Via email to d.nilsen@cityofhoodriver.gov
RE: 2025-15 Marriott Hotel Site Plan Review

City of Hood River Planning Commissioners:

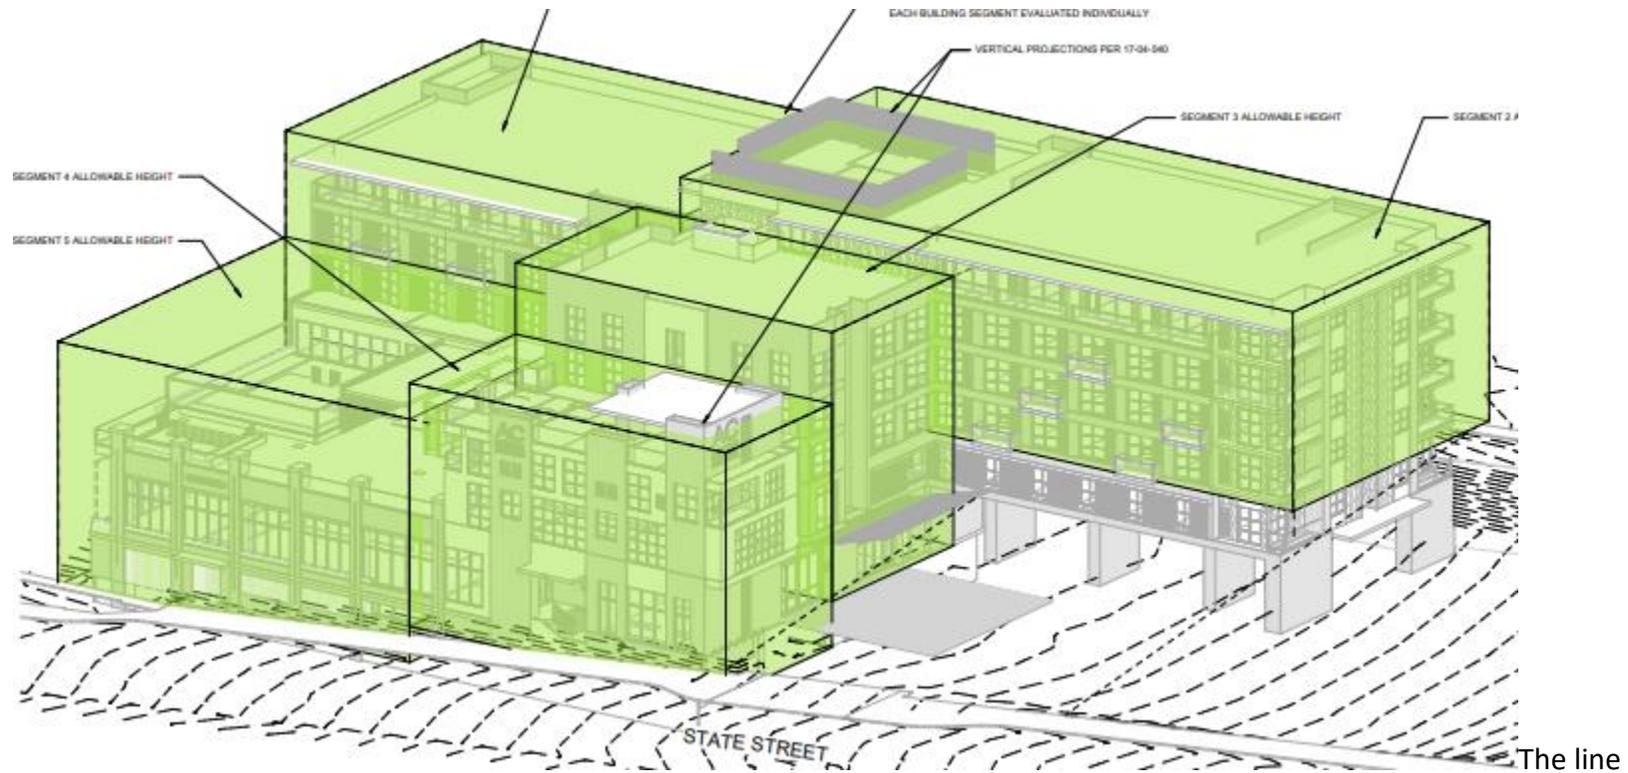
The applicant’s Compatibility Exhibit appears to be intentionally misleading as to the bulk of the proposed building.³

There are two problems. First, the photos are not on the same scale. Notice the size of the vehicles in front of the proposed building compared to the vehicle in front of the County administration building. The proposed building is obviously shrunk, thereby appearing smaller than it is.

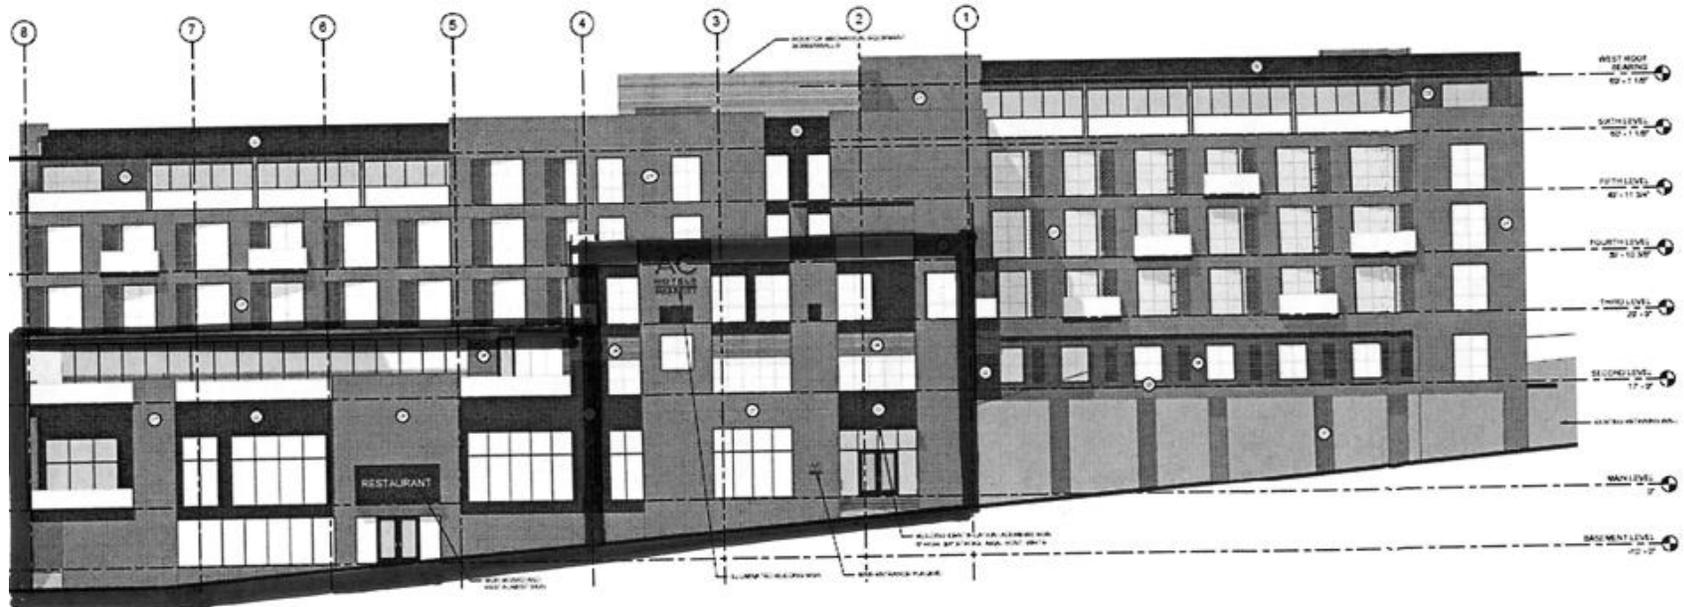
Second, most of the proposed building is not shown. The graphic below shows how the building is artificially segmented. Only the two portions of the building that border State Street are in the renderings on the preceding page. The remainder of the building – about three quarters of the structure – has disappeared.

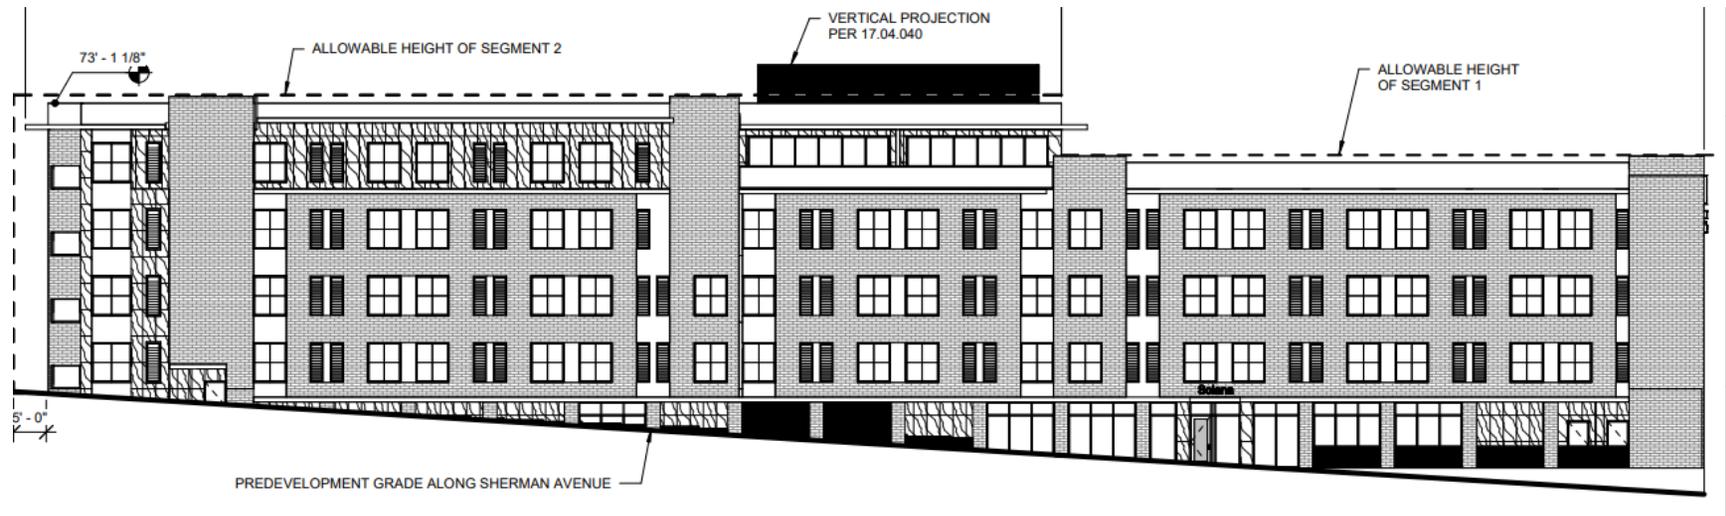
Here is the applicant's drawing of the *entire* building, from State Street. Heavy black lines have been penciled in to show the two segments that are displayed in the Compatibility Exhibit – again, a mere fraction of the building.

Clearly, the bulk of the proposed building is discordant with the buildings the applicant themselves chose for comparison. Failure to satisfy this mandatory decision criteria is, by itself, sufficient grounds for denying the application.

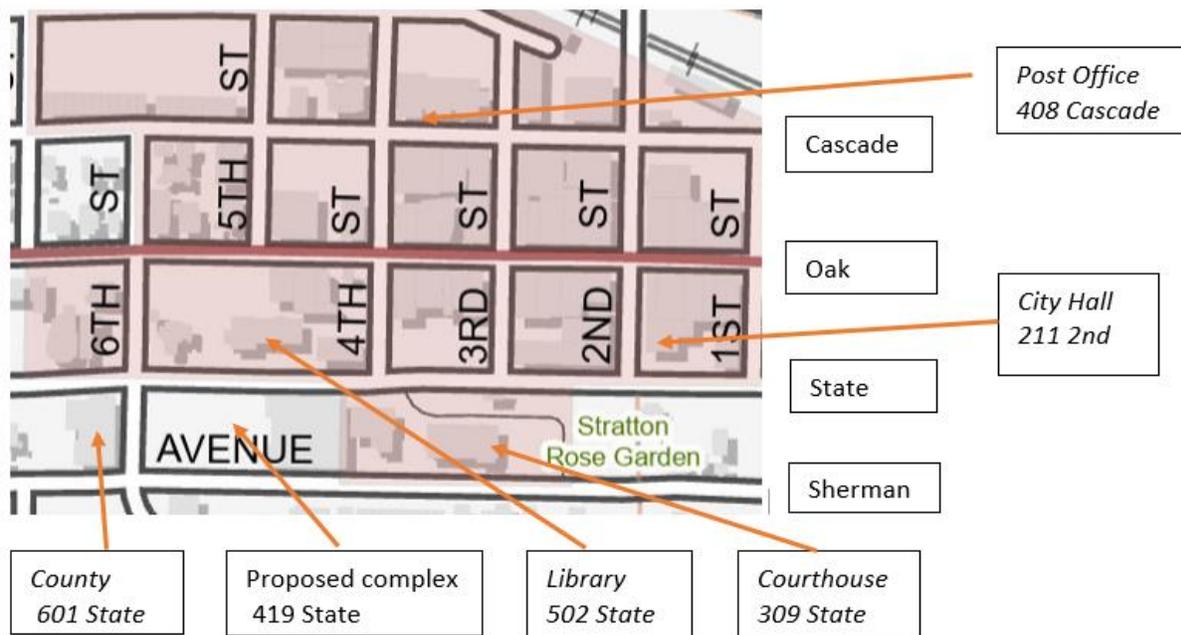
For perspective, the entire block immediately north of the site – bounded by State, 6th, Oak, and 4th – has 49 spaces. The proposed development would, at a minimum, use every one of those spaces plus 14 more, displacing all those users and creating a ripple effect that would reverberate throughout downtown and into the residential areas to the west and south.

The parking debacle is of particular concern given the number and proximity of public buildings. The proposed complex abuts the County offices and the library; is within one block of the Courthouse; and is within two blocks of City Hall and the Post Office, illustrated below.
